CITY OF WESTMINSTER			
PLANNING APPLICATIONS COMMITTEE	Date 14 June 2016	Classification For General Release	
Report of Director of Planning		Ward(s) involved Knightsbridge And Belgravia	
Subject of Report	11 Upper Belgrave Street, London, SW1X 8BD,		
Proposal	Internal and external alterations including creation of a garage on the Wilton Street elevation with associated crossover, a rear extension at fourth floor level and enlarged roof terrace at fifth floor level in connection with the use of the property as a single family dwelling. excavation works at lower ground floor, rebuilding of ground floor rear infill addition, rear extension at first floor and third floor levels, creation of terraces at first and roof levels, and installation of condensers at roof level		
Agent	Ms Rosalind Price		
On behalf of	Waltonwagner Limited		
Registered Number	16/02481/FULL 16/02482/LBC	Date amended/ completed	31 March 2016

Refuse permission and listed building consent – design and heritage impact

Proposed second floor plan

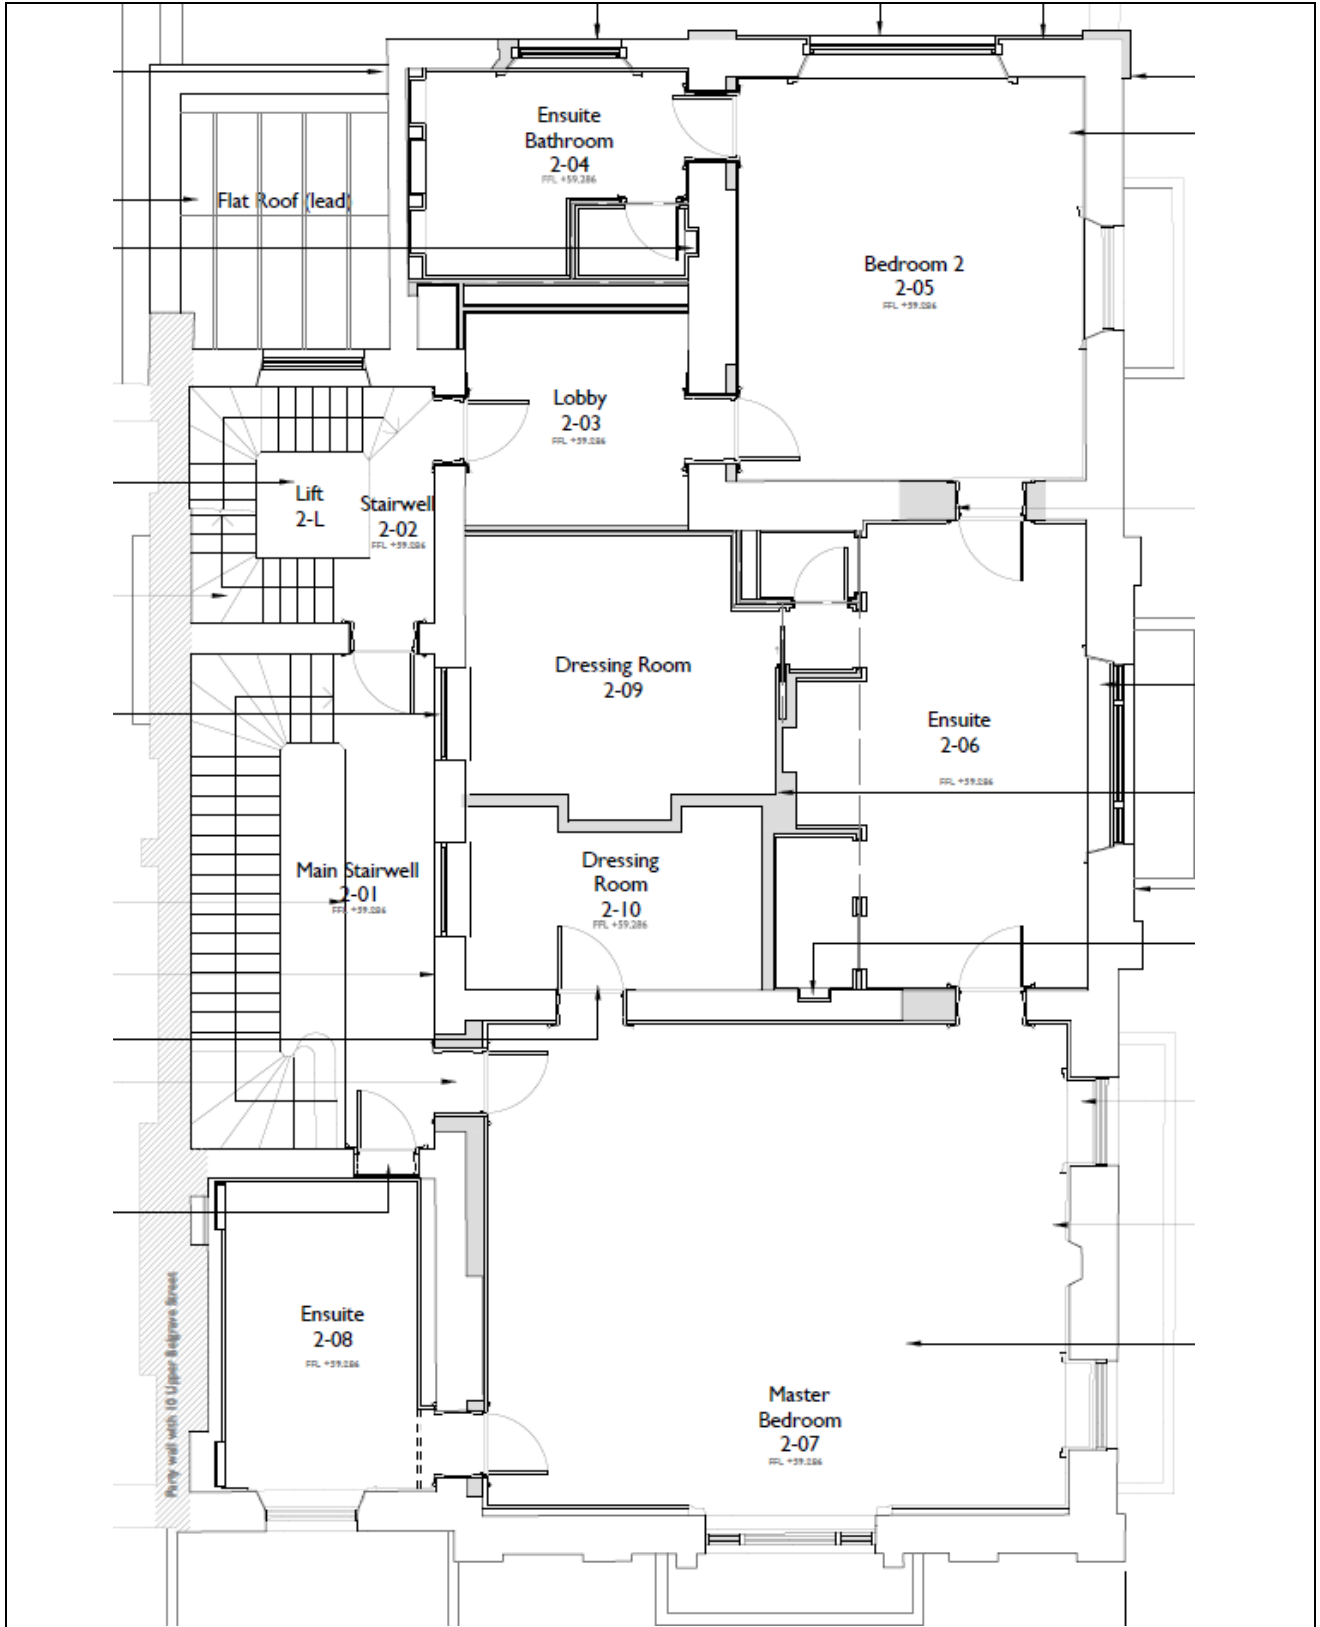
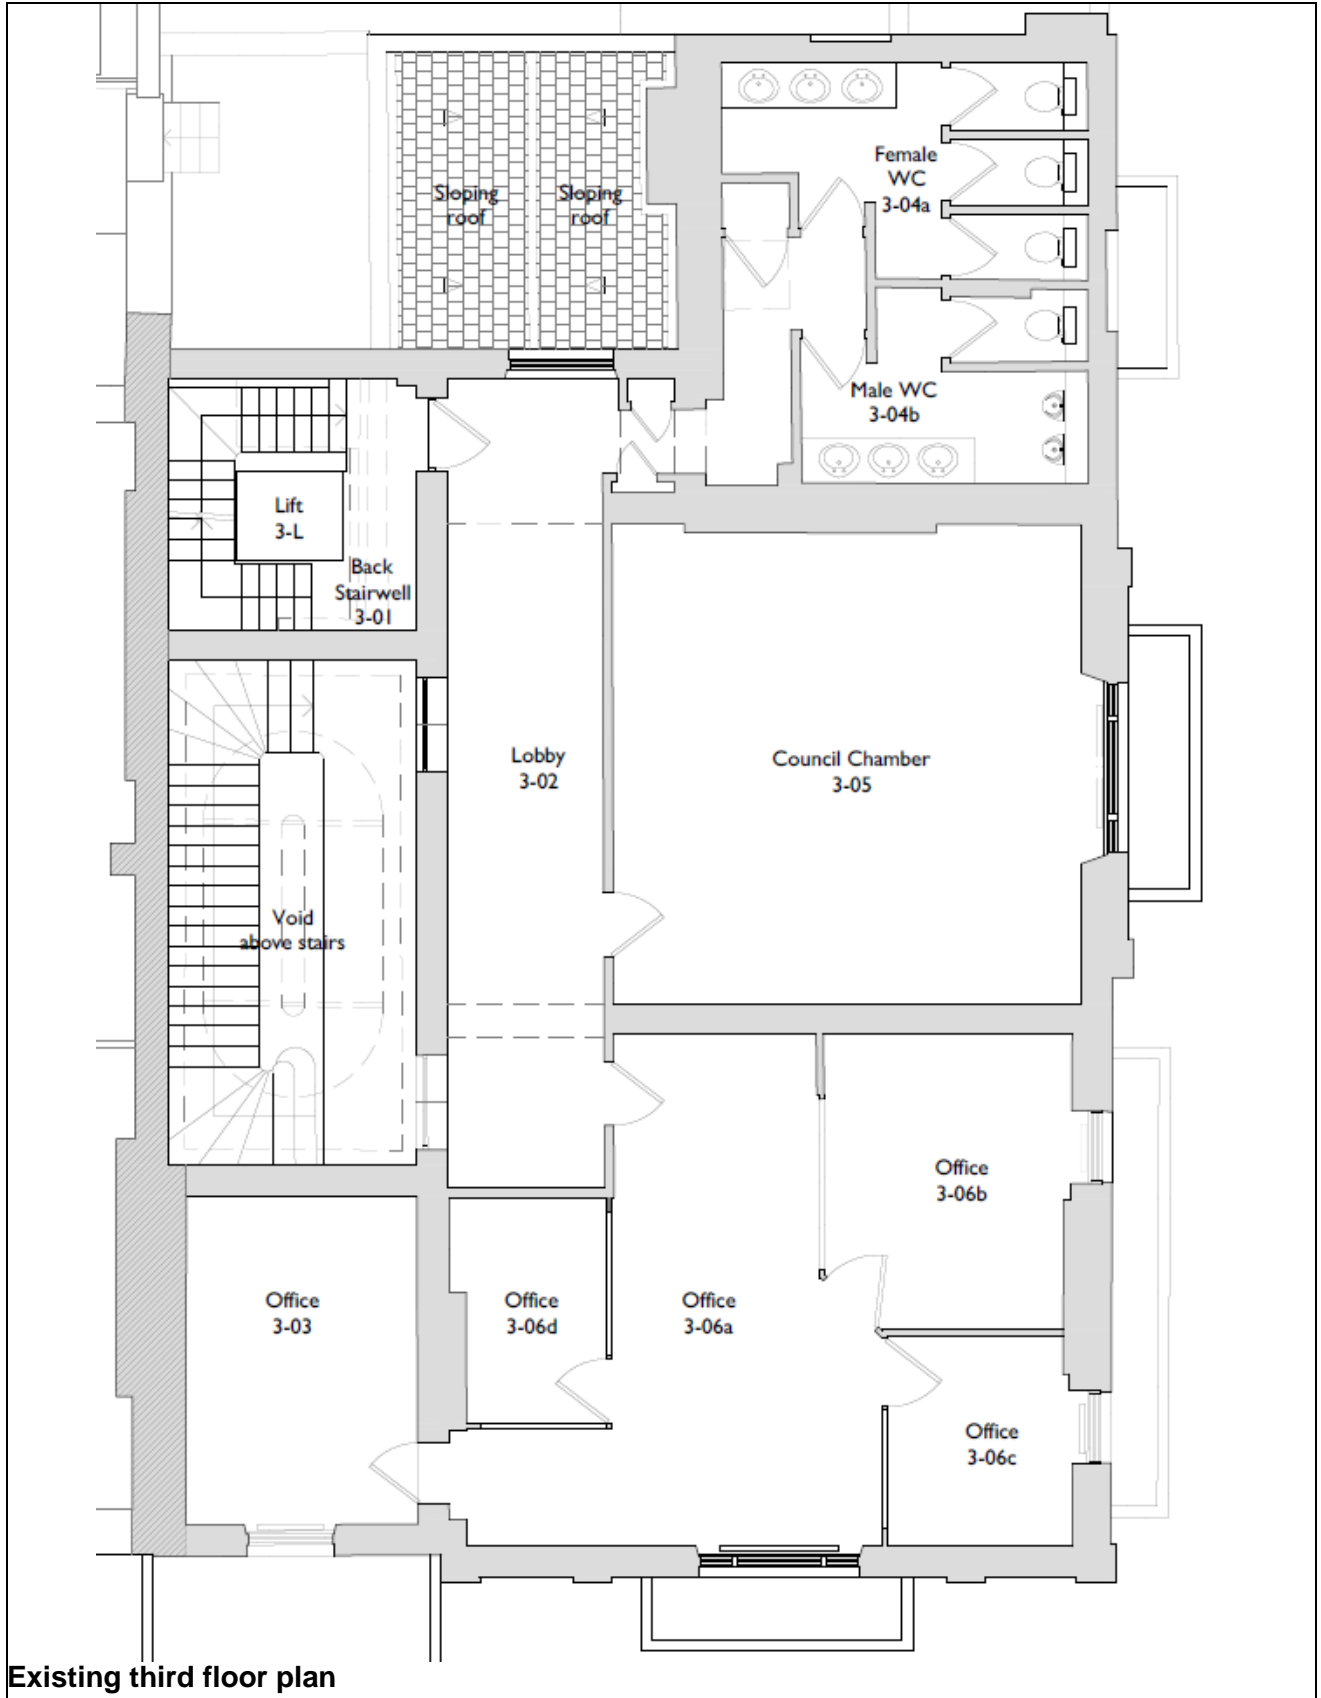
The design shown for the Master Bedroom is considered to be excessively elaborate for a bedroom at this level in the building, which is otherwise characterised by a decreasing architectural hierarchy from this floor upwards (the second floor should be notably simpler in design than the principal Ground and First Floors).

Because of its over-elaborate design and poorly designed proportions, the proposed applied plaster wall panelling and ceiling to the Master Bedroom (Room 2-07) would harm the character and special interest of this grade II* listed building. This would be against the advice set out in S25 and S28 of Westminster's City Plan: Strategic Policies adopted November 2013 and DES 1 of our Unitary Development Plan that we adopted in January 2007 and the advice set out in paragraphs 6.18-6.20 of our 'Supplementary Planning Guidance: Repairs and Alterations to Listed Buildings'. (X18AB)

Proposed fourth floor plan

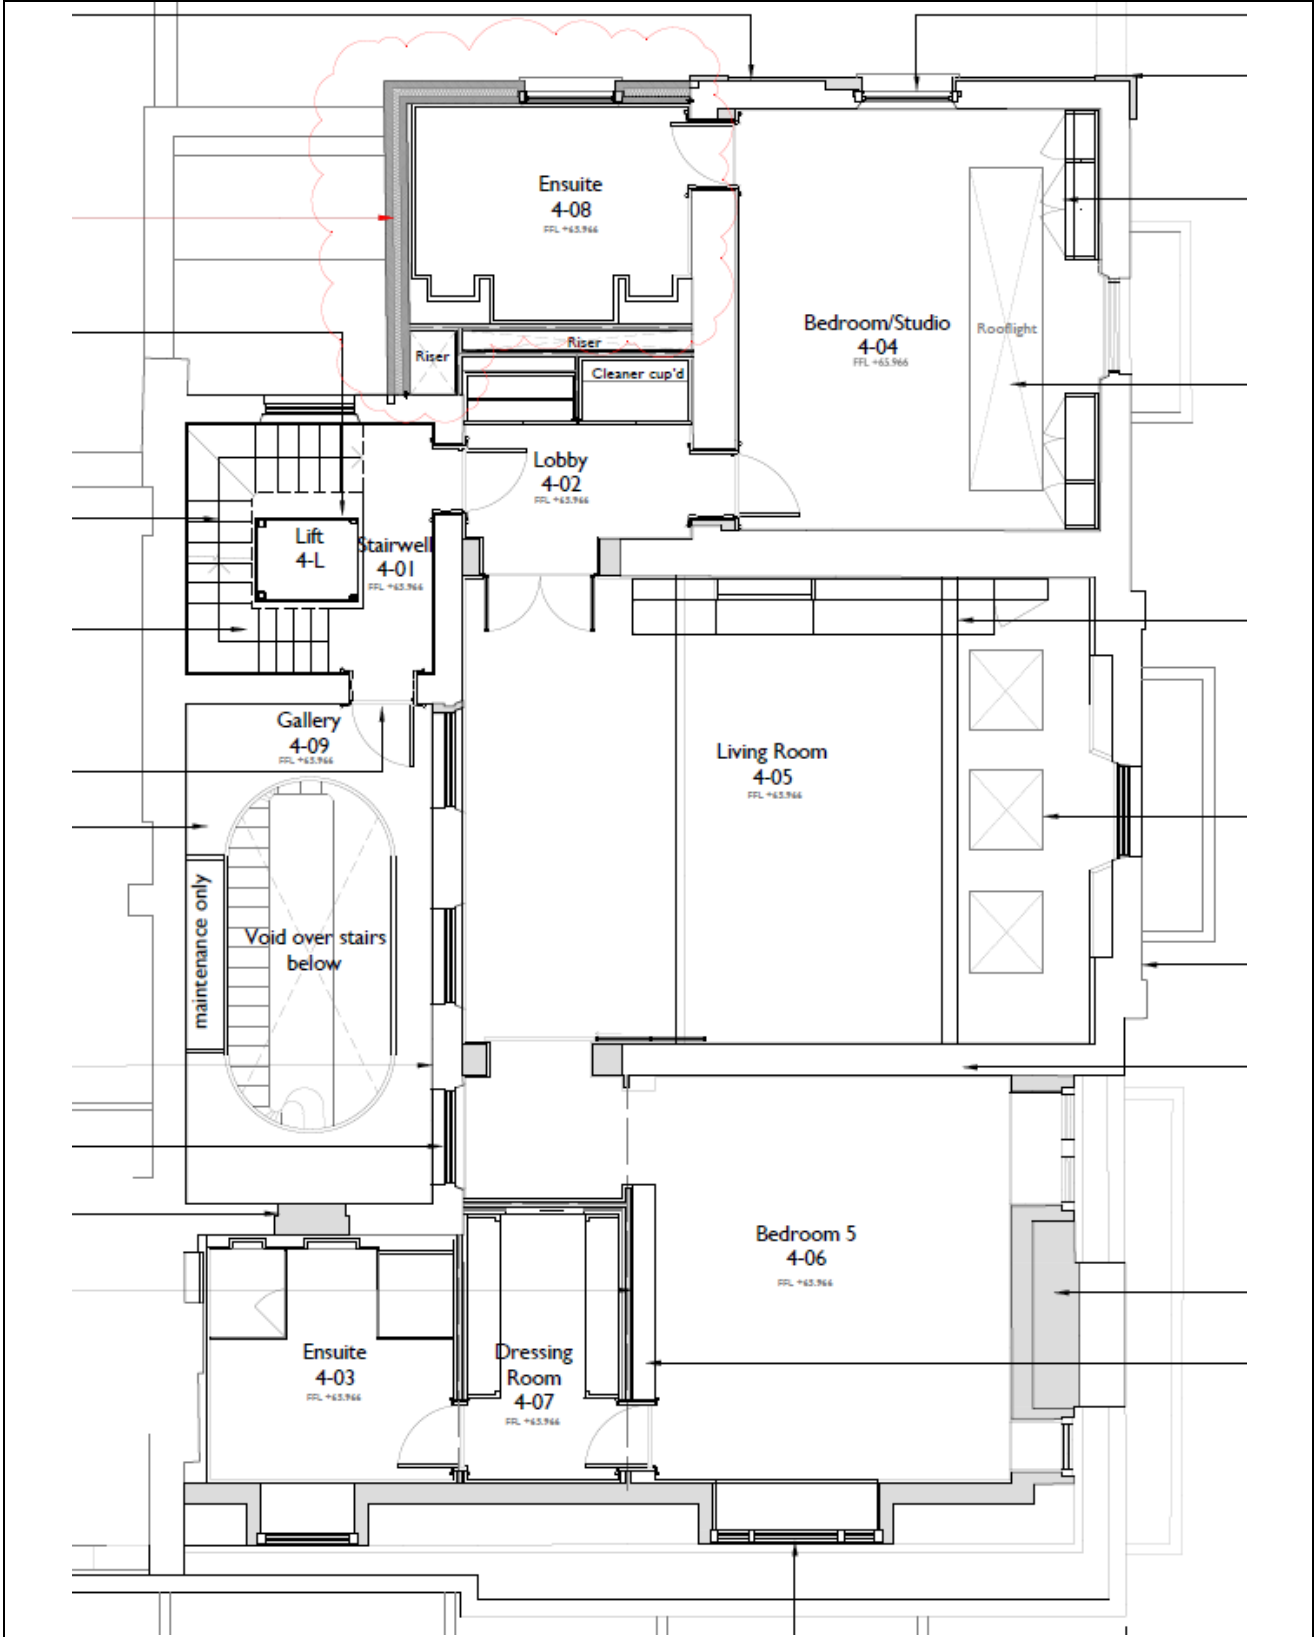
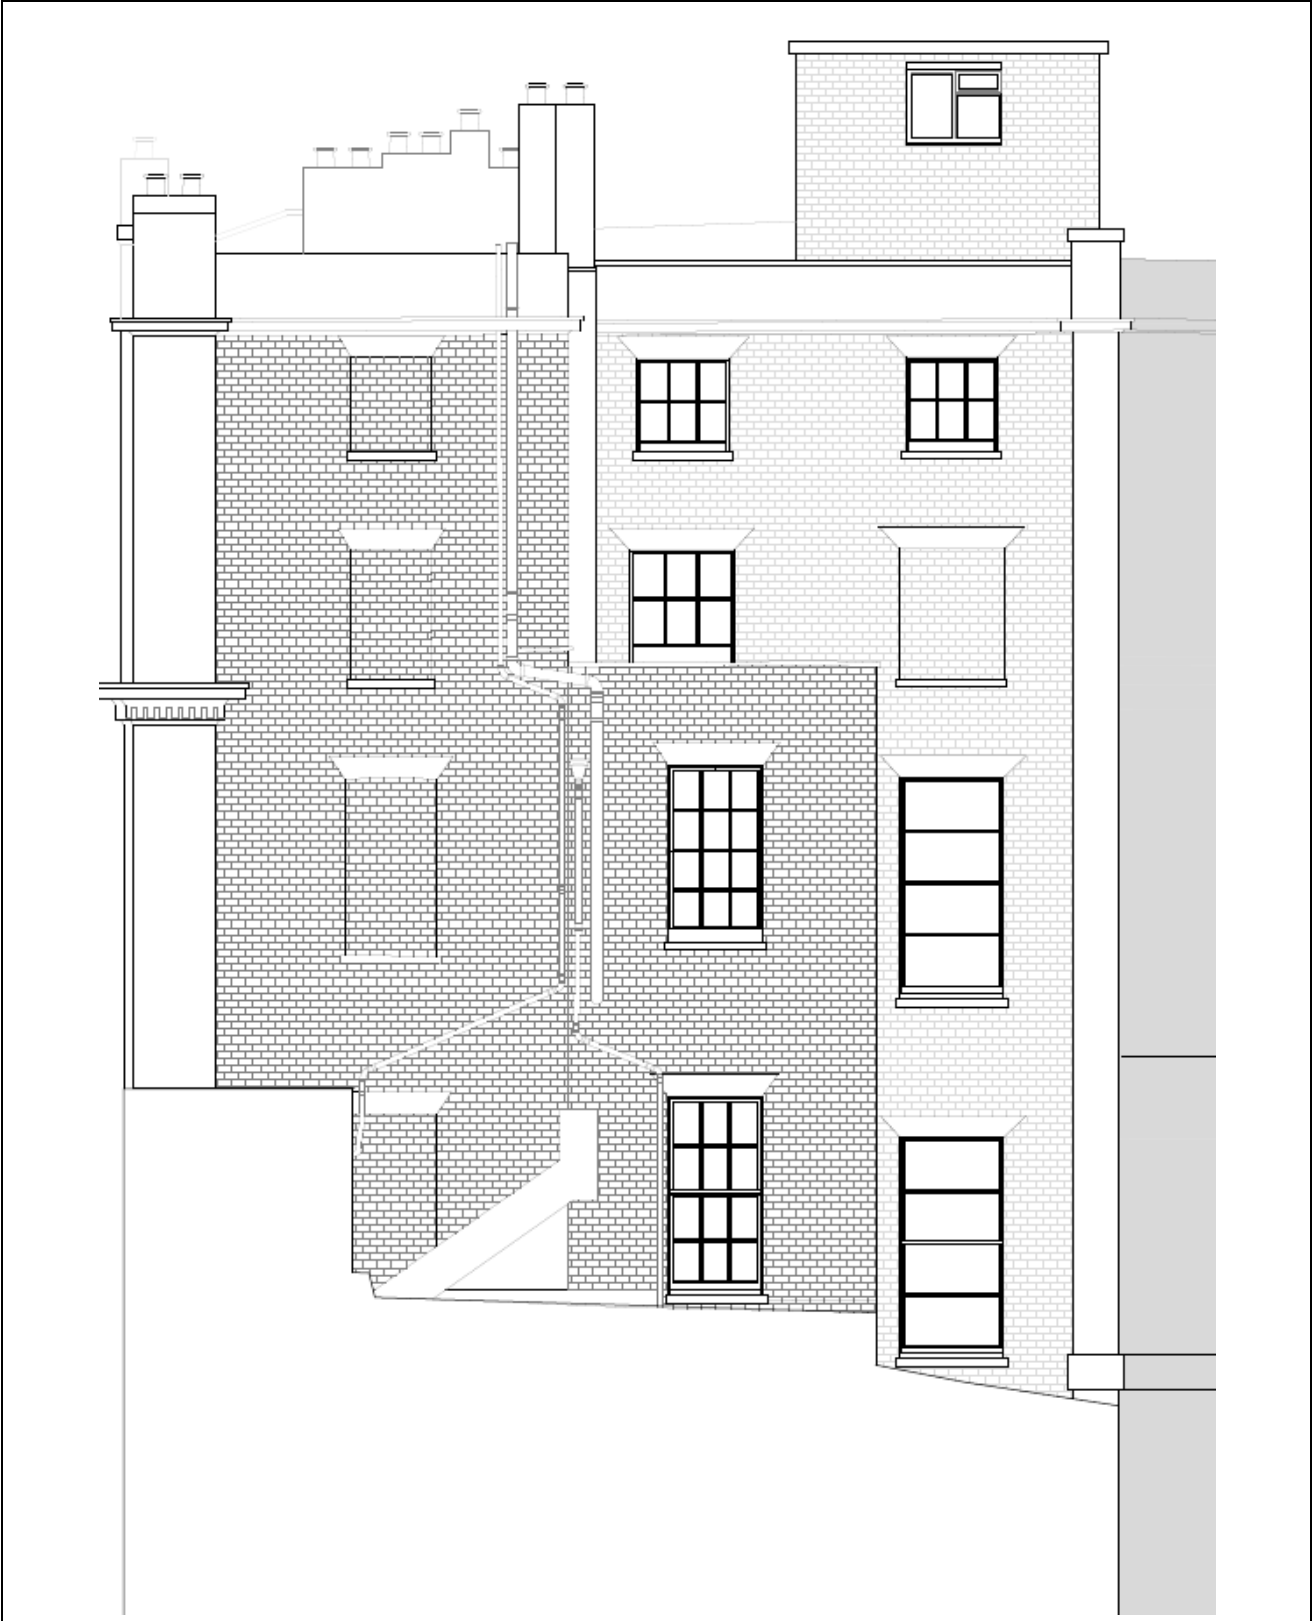
The extant approvals include for an extension to the closet wing at third floor level to be finished in brick to match the more vernacular rear elevations of the terrace and to define it from the more polite elevations of the main house and rear wing, facing Wilton Street. It is now proposed to extend the closet wing further, up to the top fourth floor, to be finished in stucco to match the main rear wing.

Policy DES 5 of the Unitary Development plan is clear that extensions should normally terminate a storey below the main parapet level – this proposal would equal the main parapet level. Whilst the policy uses the terminology of ‘normally’ so accepting that there may occasionally be exceptions, it is not considered that this property provides such an exception. In extending to this level and in the same material as the main rear wing, would create an adversely broad rear elevation, with proportions in excess of the established proportions of the principal elevations. It would blur the line between the main rear wing and the closet wing.

Because of its size, location and relationship to the original building the fourth floor rear extension would harm the special interest, character and appearance of this grade II* listed building. It would also fail to maintain or improve (preserve or enhance) the character and appearance of the Belgravia Conservation Area. This would not meet S25 and S28 of Westminster's City Plan: Strategic Policies adopted November 2013 and DES 1, DES 5, DES 9 and paras 10.108 to 10.128 of the Unitary Development Plan, adopted January 2007. and the advice set out in paragraph 2.3 and 2.4 of our Supplementary Planning Guidance: Repairs and Alterations to Listed Buildings. (X17EA)
